Please find our amended site plan attached as required.

Please See Attached, the invalid letter relating to the above notification for Bramley Village Scout Group

Appendix 5: Site Plan

ADDRESS: Bramhope Village Scout Group,
Bramhope, Leeds, West Yorkshire,
LS16 9BQ
JCA REF: 21322/EW

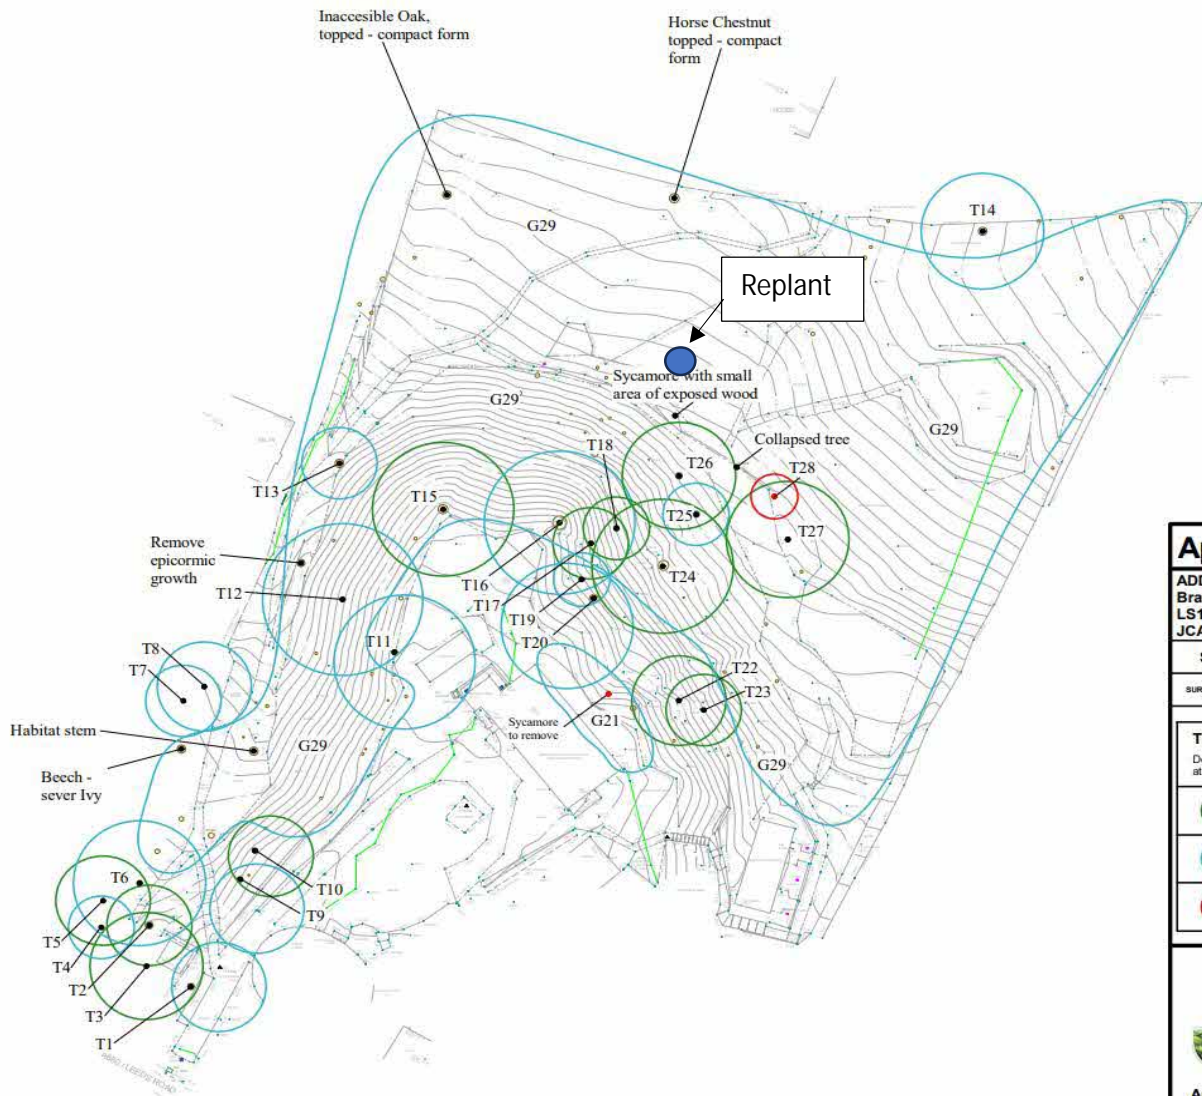
We have recommended a replant further away from G21 as there would be little chance of a replant thriving within that group due to it already being overcrowded.

We would suggest a field maple to be replanted.
